RMP 440/441 Denmark Hill

Bus Priority Improvement Works – Summary Report

November 2019

TITLE: OUTLINE DESIGN SHEET 1 OF 2

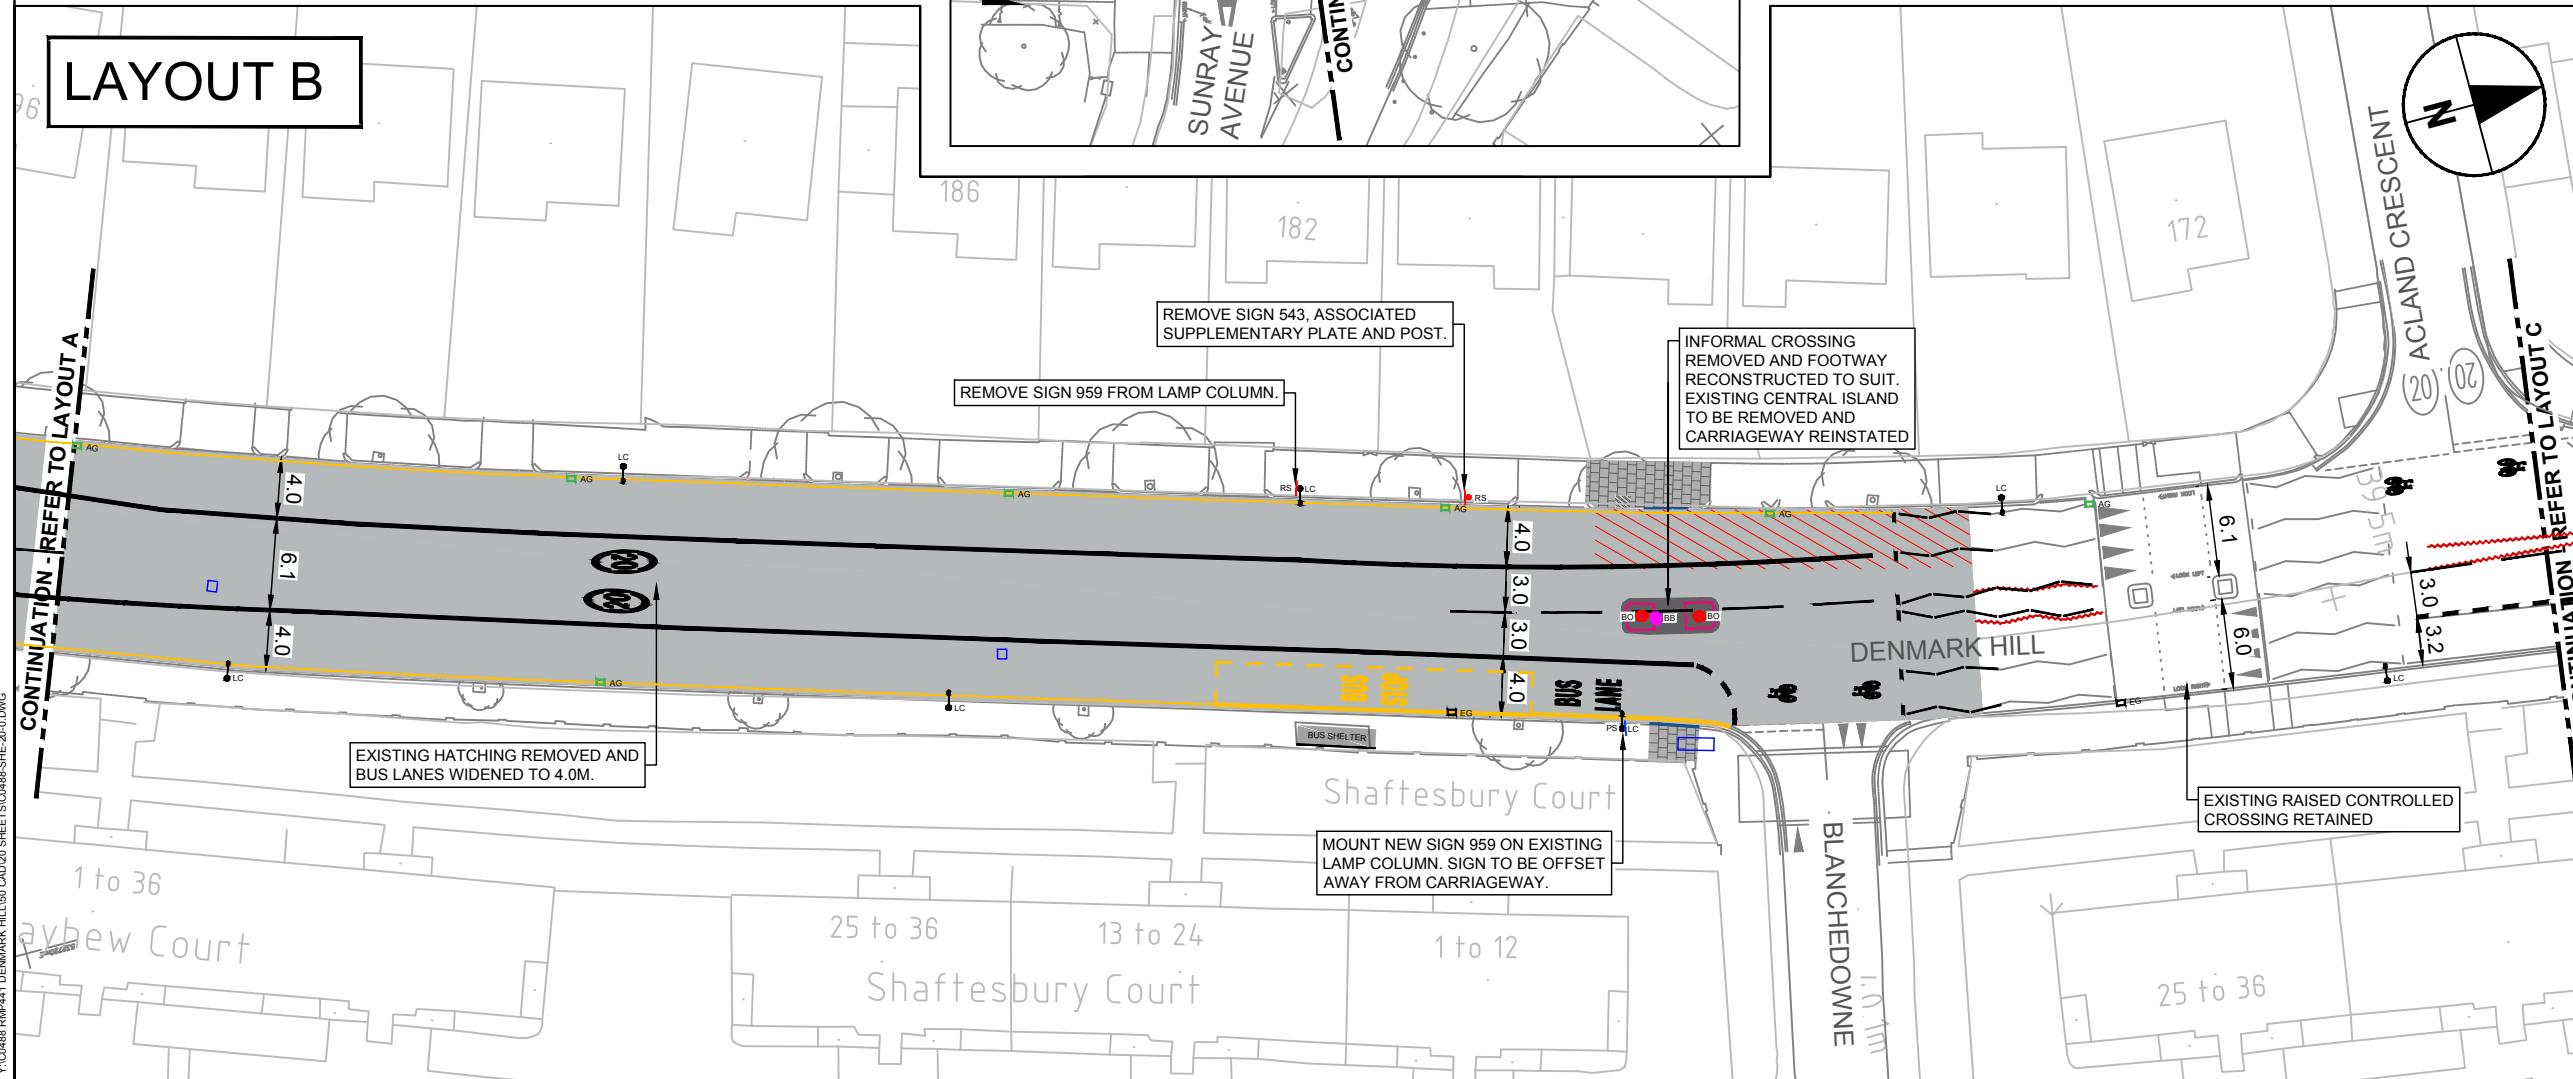
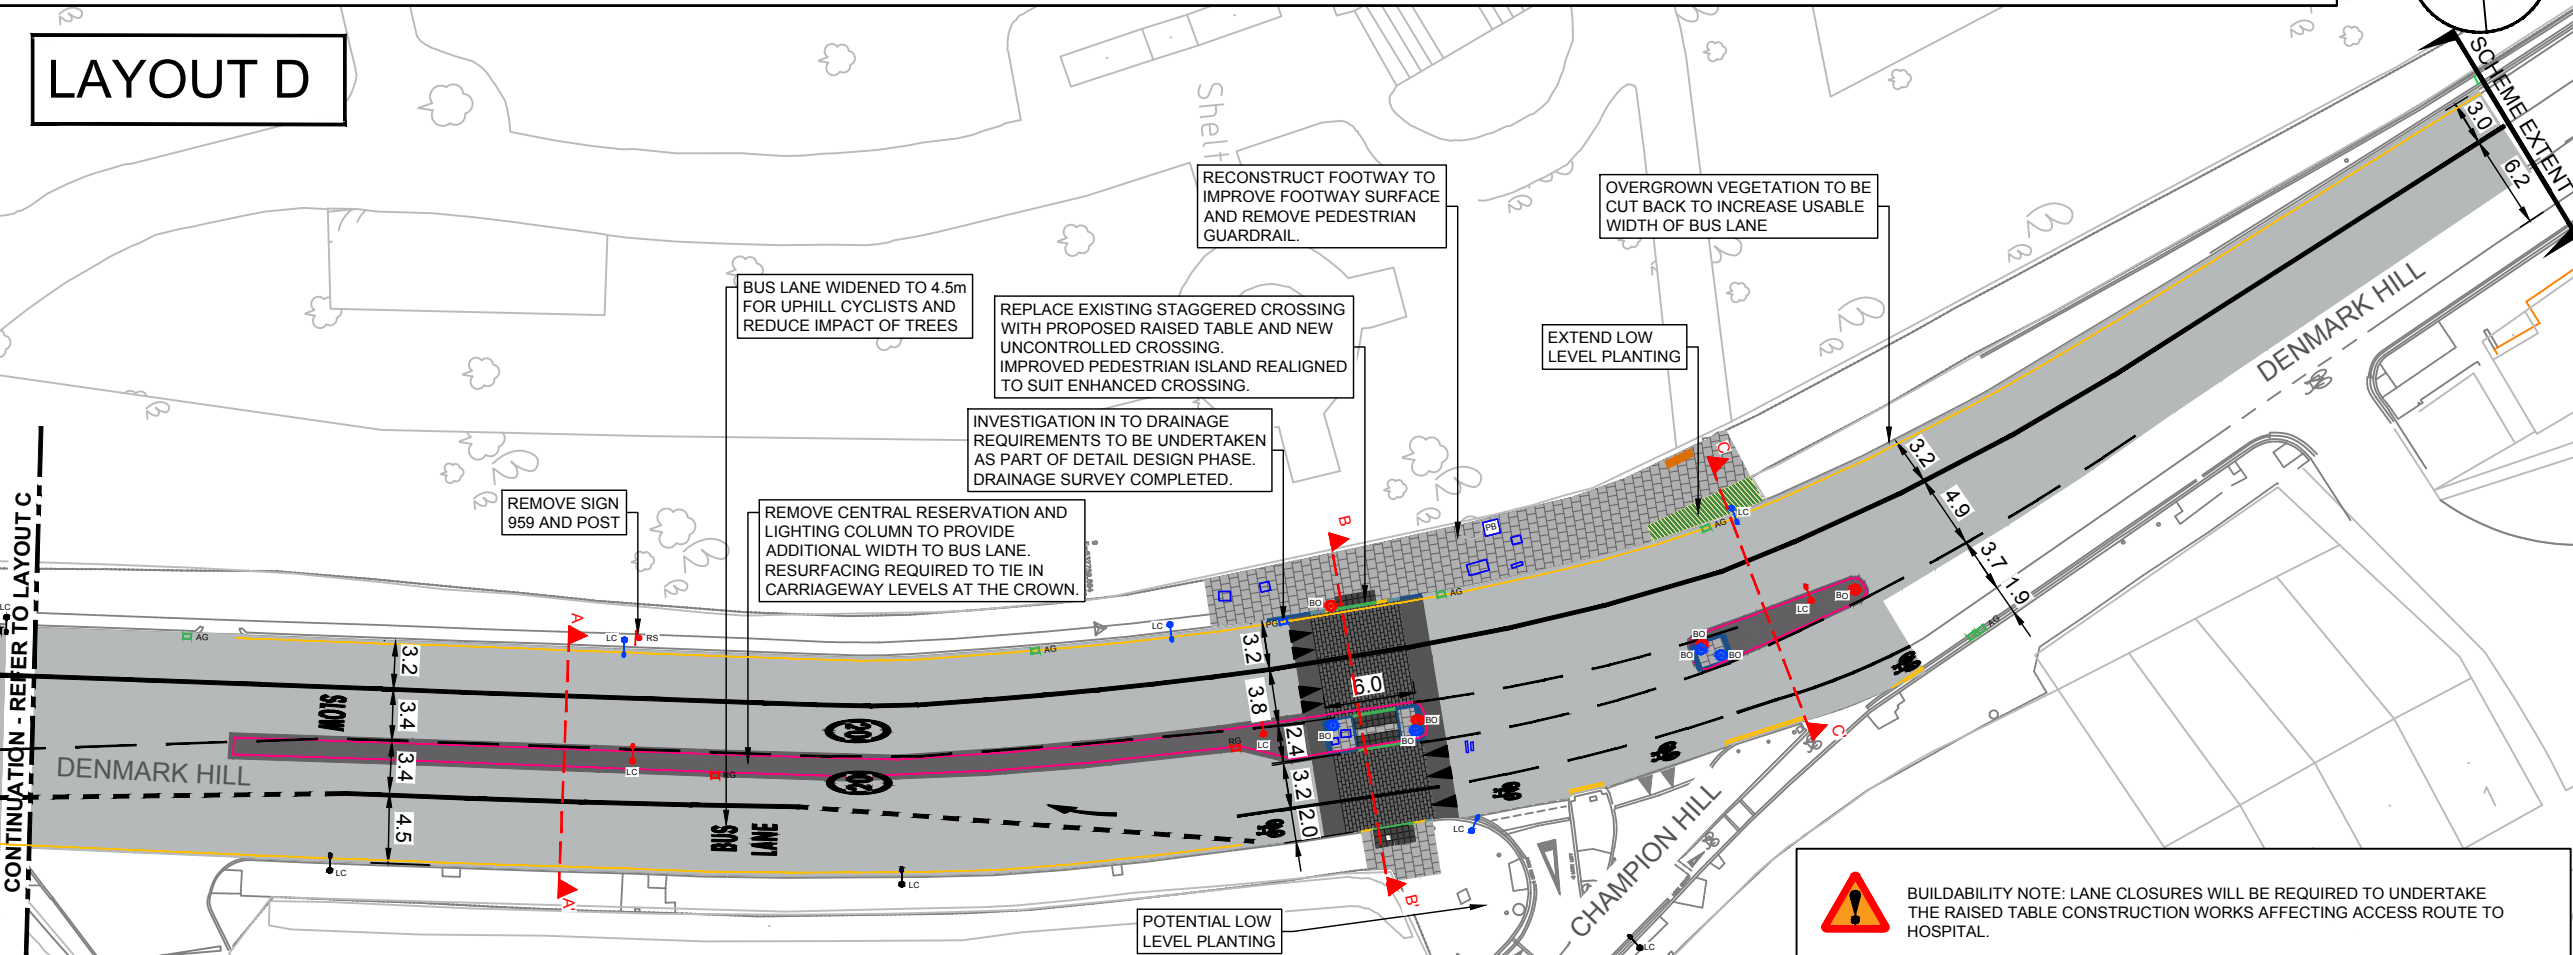
Comments	Notes
<ul style="list-style-type: none"> Perhaps try to make it so the bus lanes are widened but not too big as I think the centre line does really need to be there as it's a busy stretch of road. <p>Good idea (changes to pedestrian crossing)</p> <ul style="list-style-type: none"> Segregated cycle lanes would be much better than just widening the bus lane. A widened bus lane will encourage buses to overtake cycles when there isn't a safe amount of room to do so You should put in a segregated cycle lane all the way along! You should be installing segregated cycle tracks to mitigate this issue. Wider bus lanes will not make people choose to cycle more. Straight crossing fine, but why on earth a raised table? worse to drive over, negligible advantage for pedestrians and waste of money and resources. Pointless and sometimes dangerous as they all are It would be much better to put protected cycle lanes along this full section. This would protect cyclists from buses, taxis and other traffic, while also speeding up buses. The road is very wide for much of the space between Champion Park and Herne Hill, and there is little congestion, so space could be plausibly reallocated to cyclists. Currently, I do not dare cycle from my house to Herne Hill along this route, as I fear for my safety. <p>Ideally, we should be working towards fully protected cycle lanes and junctions all the way from Herne Hill to Camberwell Green and beyond. This is necessary to see transformative shift away from polluting, dangerous, expensive motor traffic to active transport.</p> <ul style="list-style-type: none"> Sounds sensible to me Instead of widening the bus lane, which still means buses having to manoeuvre to overtake vulnerable cyclists, why not use the additional space granted by removal of the central reservation to install a segregated cycle lane at the road margin? Straight crossings are better. Other kind can be a trip hazard The first bus stand on entry to Orpheus street should be moved/ taken away. Causes numerous traffic jams having a bus parked both here and at the second stand. Beeping/ engine noise from standing buses and cars in traffic particularly annoying to residents of 23 Denmark Hill Create segregated cycle lanes instead, this could even be light segregation using "orcas" or wands. Put in a bustop bypass. 	<p>Due to presence of existing junctions, traffic island and pedestrian crossing along the route, provision of a segregated cycle lane will not be achievable. Cycle road markings will be included as part of the design to ensure greater awareness</p> <p>The raised crossing ensure that mobility impaired users are able to cross safely.</p> <p>The current proposals do not extend as far as the junction with Orpheus Street. The area was recently improved as part of the Camberwell Town centre scheme</p>

Comments	Notes
<ul style="list-style-type: none"> • I do not think wider bus lanes are a good idea, as they will simply encourage close passing of cyclists by buses (which can sometimes already be a problem). There is space on Denmark Hill, with the big central reservation and wide pavements, to introduce segregated cycle lanes, which would be a better solution. <p>Straight crossings are always better</p> <p>See above - do not widen the bus lanes but build segregated cycle lanes. Speed cameras would also help, as my experience of walking, cycling, driving and taking the bus round there is that speed limits are frequently ignored.</p> <ul style="list-style-type: none"> • I have not observed the issues mentioned moreso, there are more commuters heading towards central London than towards Herne Hill every single day and as such the congestion is expected in the previous direction. <p>Secondly, we have already suffered a lot with the just completed roadworks around Camberwell Green and Denmark Hill. Lastly, with the introduction of new crossing at Camberwell by the shopping centre has made things even worse - two closer set of traffic lights as well as the introduction of crossing closer to the King's College leading to three crossings before getting to the hospital is now seriously causing jams during rush hours.</p> <p>I don't think this (the pedestrian crossing facility) is even used that much often. Thus, it will be better removed.</p> <p>The issue really has to do with the cyclists because they struggle a lot to get up the hill and usually keeps swerving in and out of their lane. But the cycle lane is more than sufficient if used properly.</p> <ul style="list-style-type: none"> • Create segregated cycle lanes instead, this could even be light segregation using "orcas" or wands. Put in a bustop bypass • They would do the trick, but a stepped cycle track would give clearer space to all road users - better safety for cyclists, and a clear indication of "who" belongs "where" Support (changes to pedestrian crossing) <p>Please look at a one-way (southbound) stepped cycle track instead of the wider bus lane; and raising the southbound (uphill) cycle lane further north on to a step to offer more</p> <ul style="list-style-type: none"> • Widening a bus lane will make extra traffic for the road users. • The current width is adequate for bus and bicycles. 	<p>Due to presence of existing junctions, traffic island and pedestrian crossing along the route, provision of a segregated cycle lane will not be achievable. Cycle road markings will be included as part of the design to ensure greater awareness</p>

Comments	Notes
<ul style="list-style-type: none"> A wider bus lane which, in theory, allows a bus to overtake a cyclist will make a cyclist feel less safe. The road also suffers from speeding cars, despite the 20mph limit. In order to ensure that cyclists are not delaying buses, while also making them feel safe cycling slowly uphill (at a relatively large difference to the speed of passing traffic), the only safe way is to create a segregated cycle lane. This can be trialled with a low-cost option of installing 'wands' or 'armadillos' to separate cyclists from traffic. A wider lane at the bus stops will be the minimum solution, though ideally, built-out bus stop islands should be trialled, with cyclists passing 'behind' these, on the pavement side. <p>I support the proposed changes to pedestrian facilities.</p> <p>Enforce speed restrictions. Cars/motorbikes exceed the speed limit, particularly on the downhill. Narrowing the roadway, as per the plans, is a good idea, however it needs to be done in conjunction with safer cycle provision.</p> <ul style="list-style-type: none"> The main delays appear to be on the high street and leading up to the junction with the A2216, rather than this relatively short section of Denmark Hill. The road at this point is already wide, such that cars and buses often take up both lanes. <p>The Denmark Hill Road at this point is often fast moving and rarely do vehicles adhere to the 20 mile an hour speed limit. The traffic island at Blanedowne represents vital protection and space for cyclists turning into this road when approaching from Herne Hill and onto the dedicated quietway. Taking this away means that cyclists will have to dismount at the controlled crossing the cycle back up the road. This doesn't feel very cycle friendly.</p> <p>Similarly the staggered crossing provides an opportunity for both cars and cyclists to cross from the quietway onto the main road. This is a fast and busy road, and while the raised crossing may work for pedestrians, it's unclear how this works for cyclists and traffic coming out onto Denmark Hill or approaching from Herne Hill and turning into Champion Hill. The current staggered crossing provides vital protection for cyclists and the staggered crossing allows appropriate advantage to be taken of gaps in traffic for crossing.</p> <p>More should be done to reinforce the 20 mile an hour speed limit on this stretch of road - essentially it is double laned highway which more often has 2 cars abreast racing down it.</p> <ul style="list-style-type: none"> Acland Crescent, Ferndene Road junction geometry needs to be tightened. 	<p>Due to presence of existing junctions, traffic island and pedestrian crossing along the route, provision of a segregated cycle lane will not be achievable. Cycle road markings will be included as part of the design to ensure greater awareness</p> <p>This can be looked at as part of the current proposals</p>

Comments	Notes
<ul style="list-style-type: none"> <li data-bbox="140 159 951 792"> <p>I live in Ferndene Road and I frequently use buses and drive in this area.</p> <p>I do not object to the proposed new items, but I do not see the need to remove the items proposed, or why this scheme is priority for public money. There is a 20 mph speed limit and the traffic is rarely heavy in the stretch in question. I have never been aware of cyclists holding up buses, and it could only apply to a few yards before and after the Champion Hill bus stop (not shown on the drawing), where the central reservation is, and when buses are stopping anyway. I am sceptical that this makes any material impact on bus times.</p> <p>The central reservation is an attractive feature for the road, and any green planting is welcomed. I believe it helps traffic calming. I wonder if Lambeth Council has been consulted on these plans.</p> <p>Did you decide not to mention bottle necks both at Herne Hill and Denmark Hill/Champion Park junctions, even if quicken with cycle overtaking and also pedestrian safety as reasons for the central reservations, along with being attractive features – curious that you filtered out these thoughts from me?</p> 	<p data-bbox="975 159 1422 344">There will be some new planting in the vicinity of the traffic island to compensate for its removal. Officers at LB Lambeth have been consulted and regularly informed of progress of the scheme</p>
